Rhode Island Airport Corporation

ADDENDUM NO. 1
Invitation for Bids No. 36109
REHABILITATION OF DELIVERY DRIVE PARKING LOT
Rhode Island T. F. Green International Airport

Prospective proposers and all concerned are hereby notified of the following changes in the document(s) related to **IFB 36109**. These changes shall be incorporated in and shall become an integral part of the contract documents.

DRAWING NO. 14

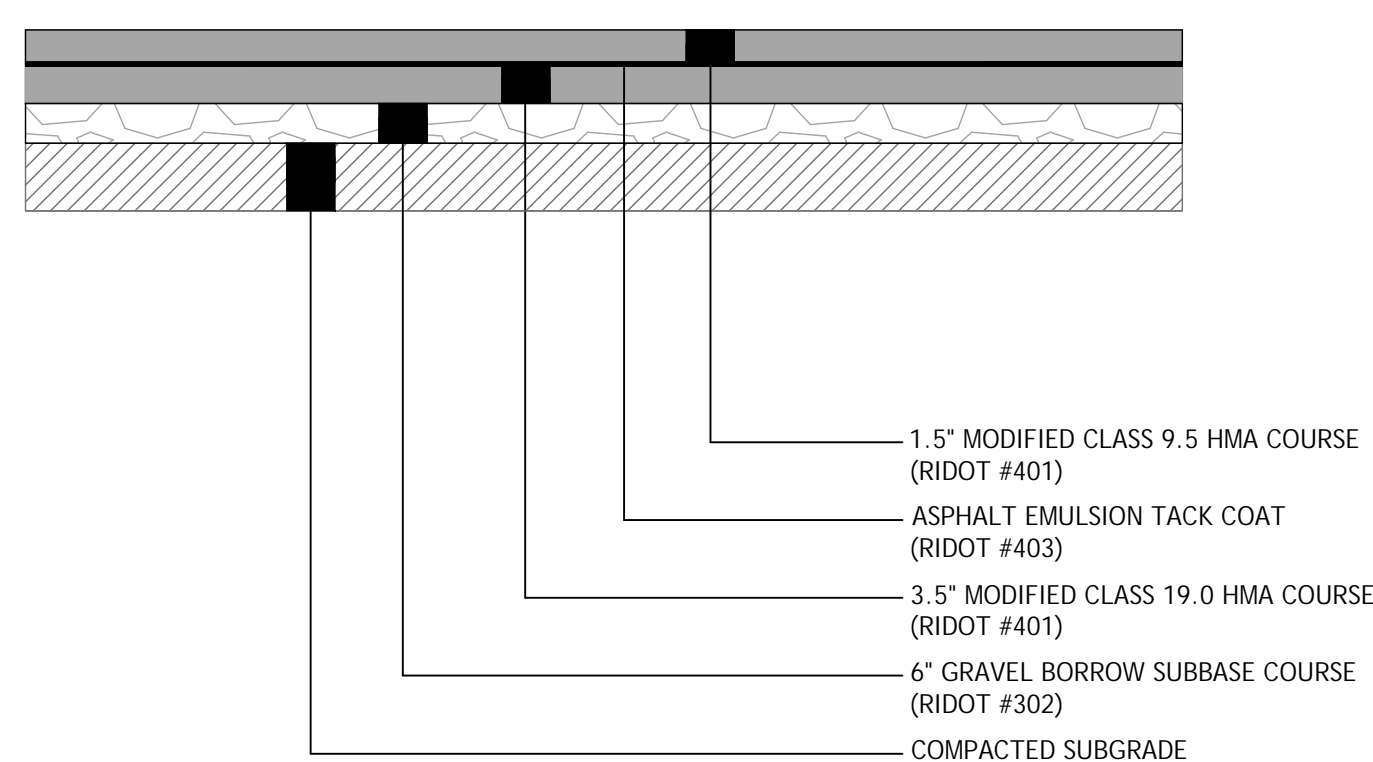
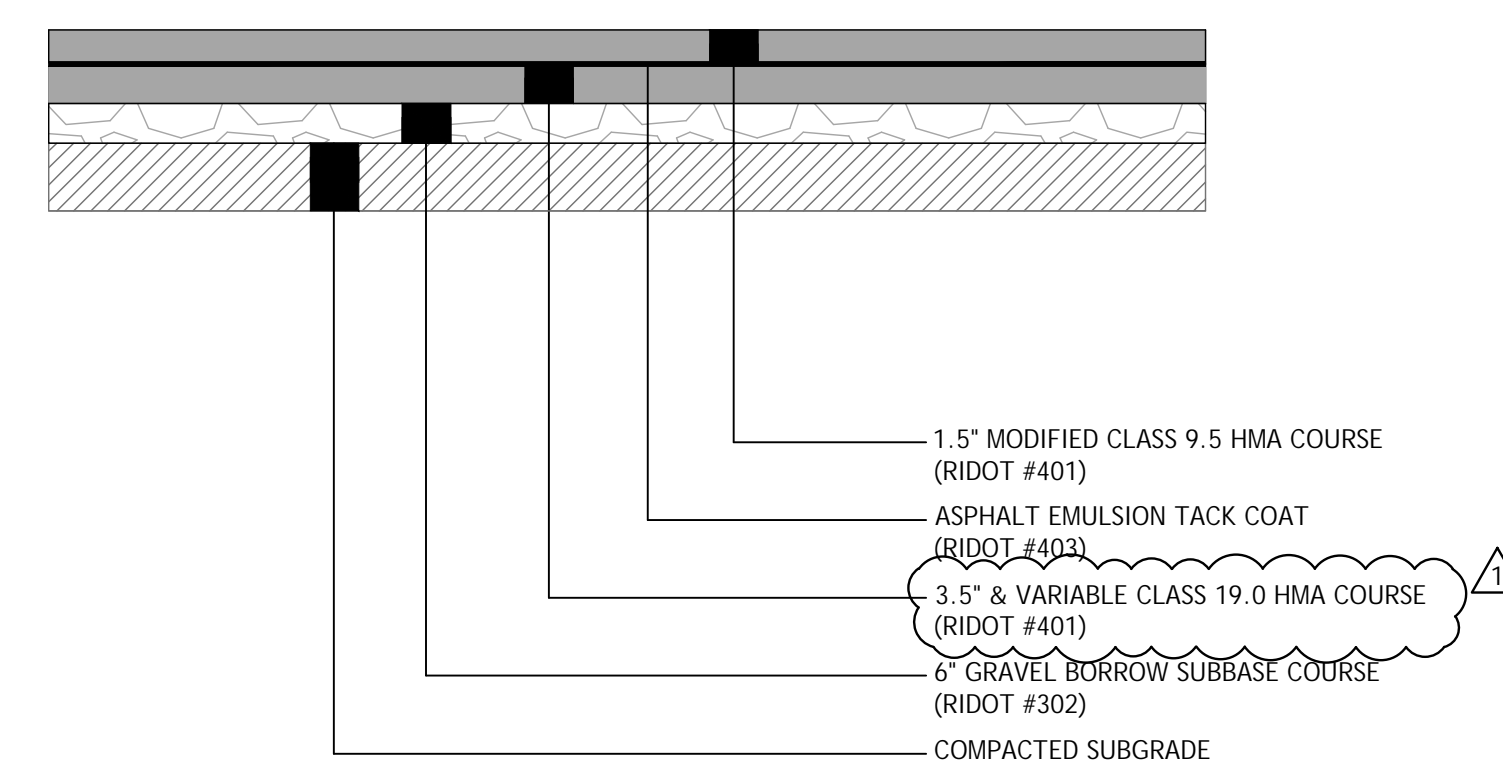
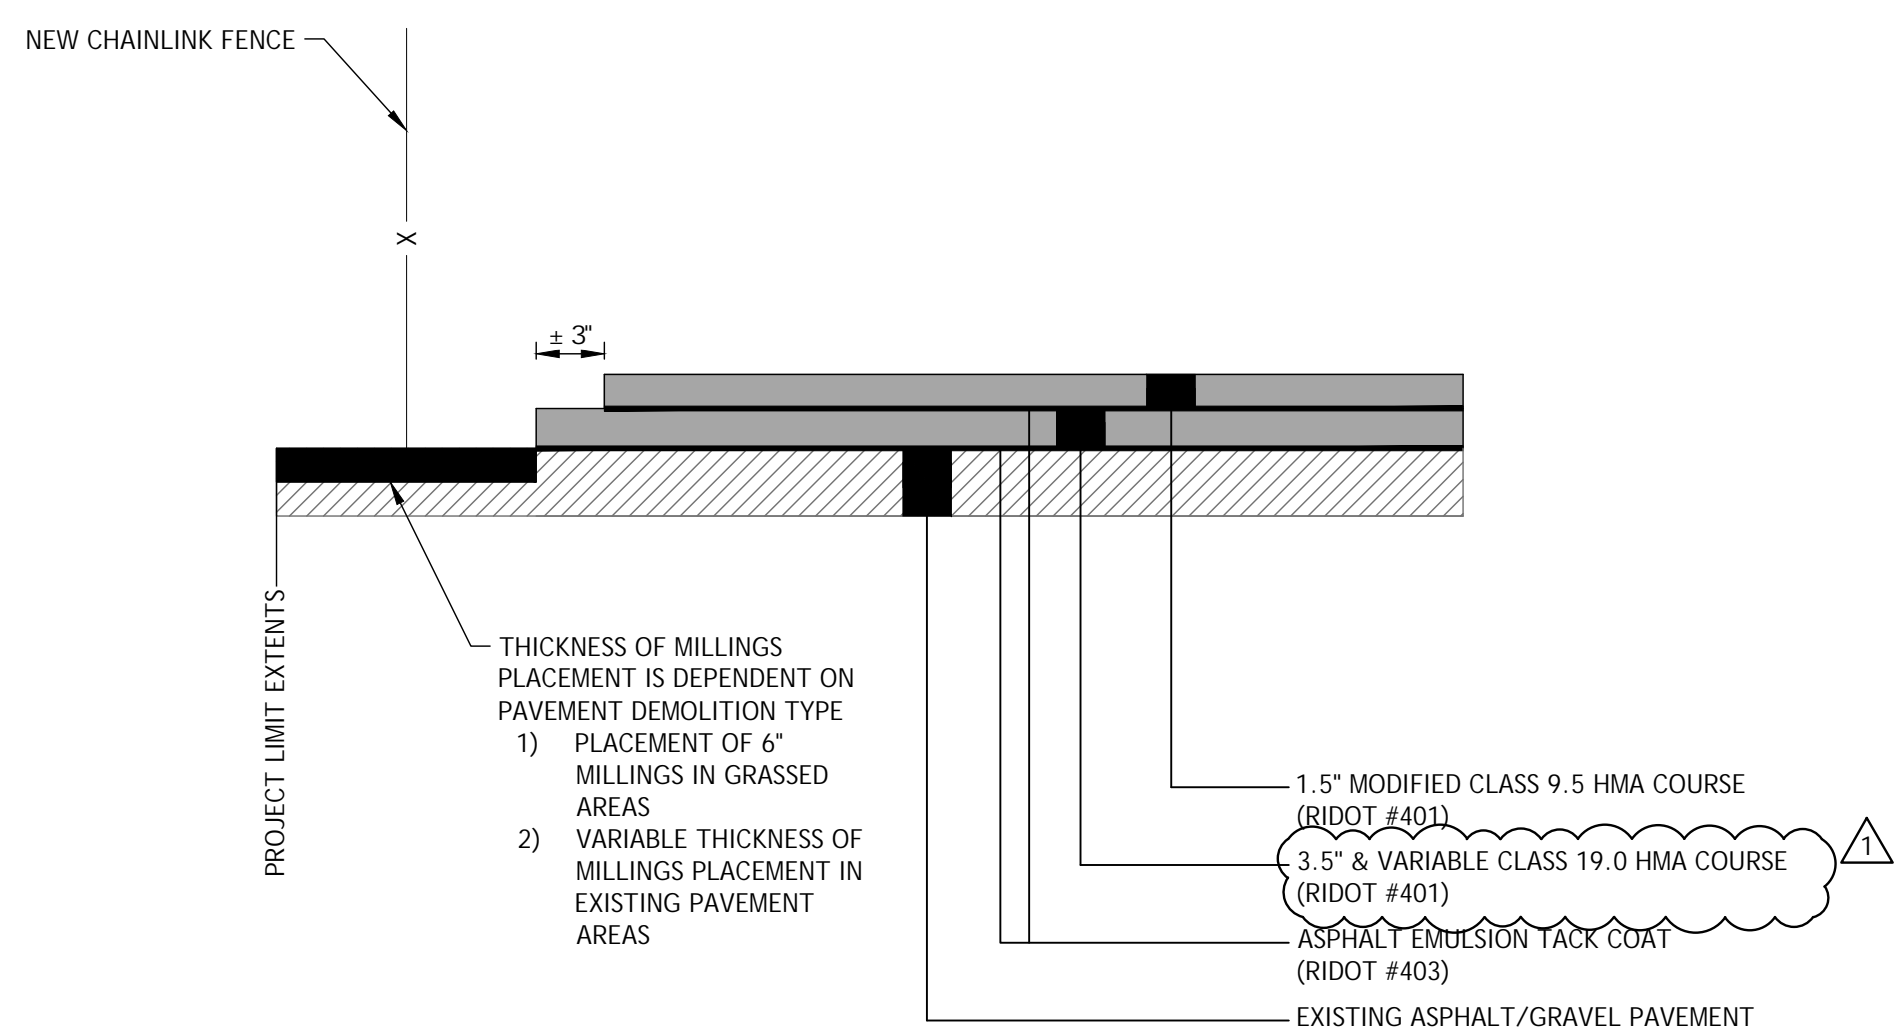
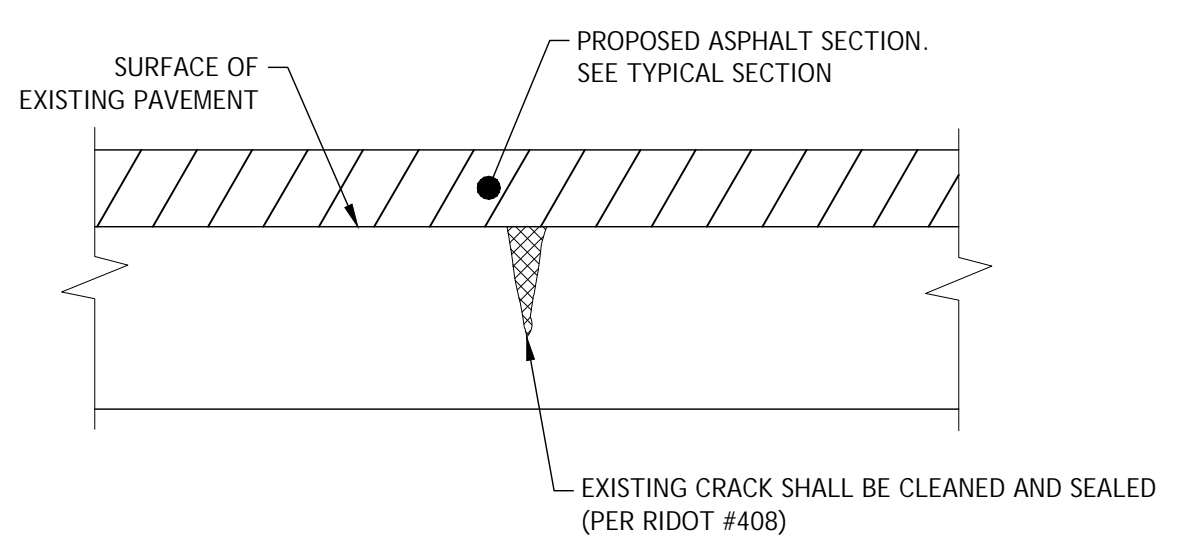
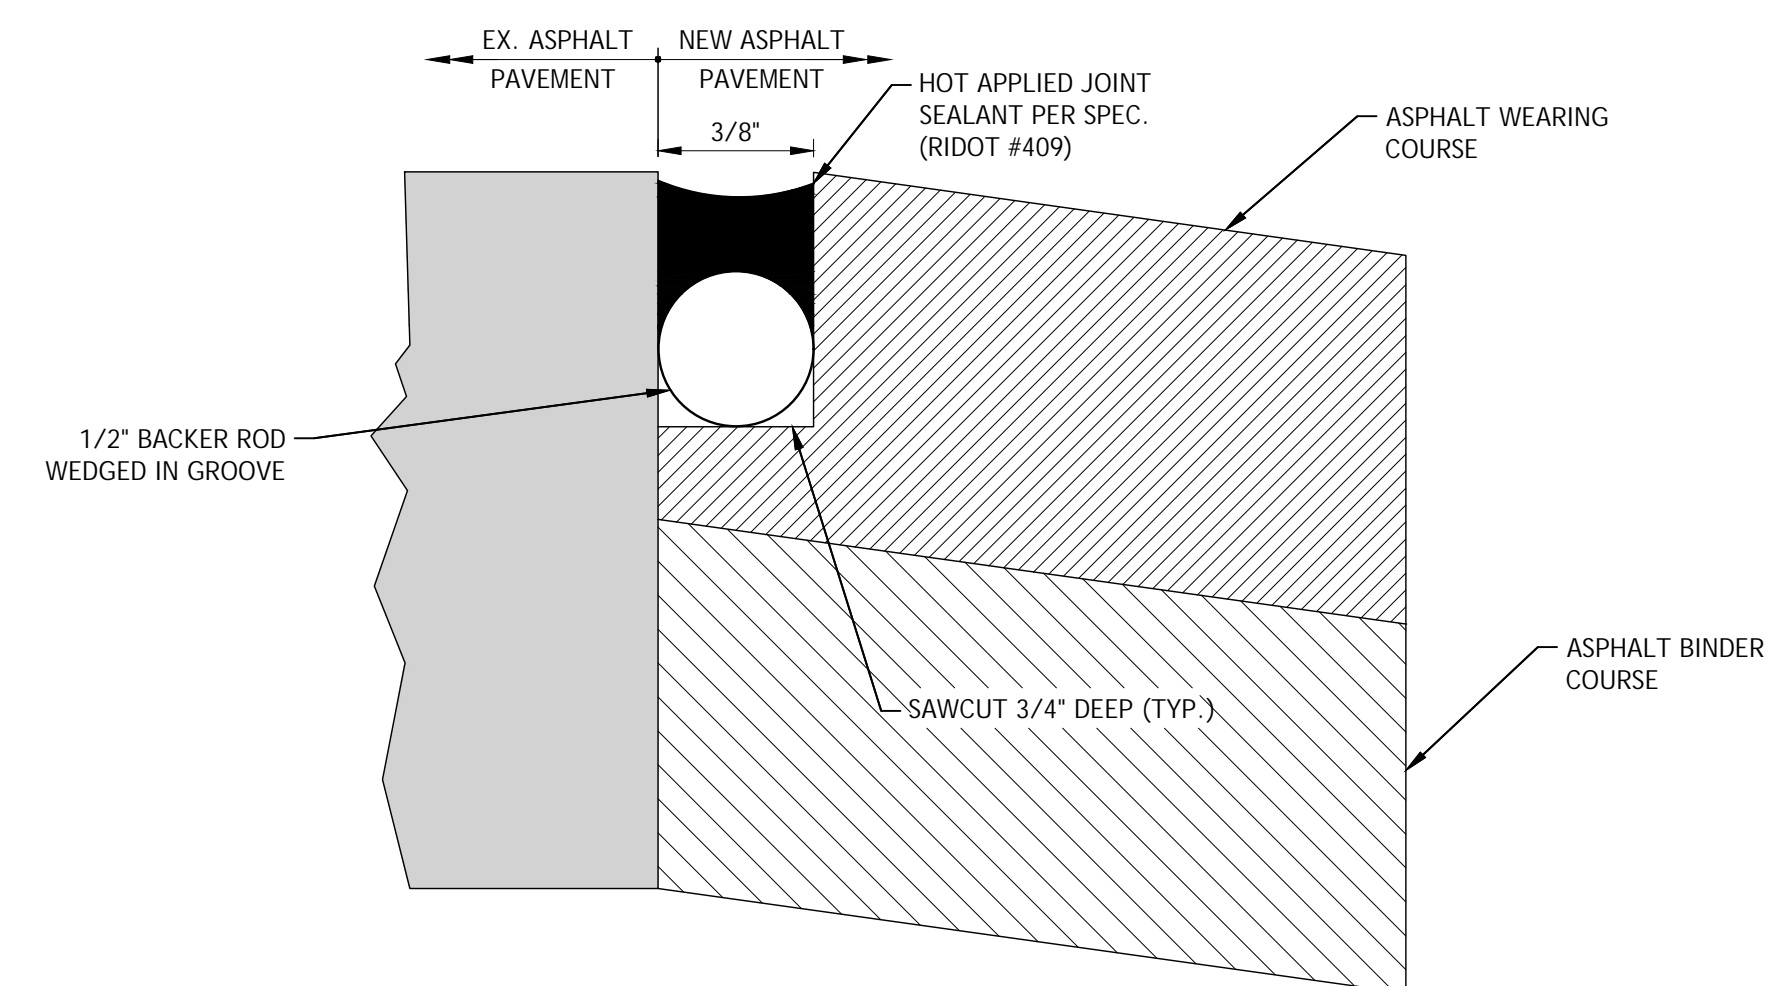
iv. Sheet 14

- Replace sheet 14 in its entirety and replace with sheet 14(R-1) attached to this addendum. Asphalt Overlay Section has been updated.

1. Please clarify that Modified 19.0 is required for item 23. Usually, modified oil is not used in base mix.

Answer: *'Modified' has been retracted from items referring to Class 19.0 HMA pavement with the plan set and specifications.*
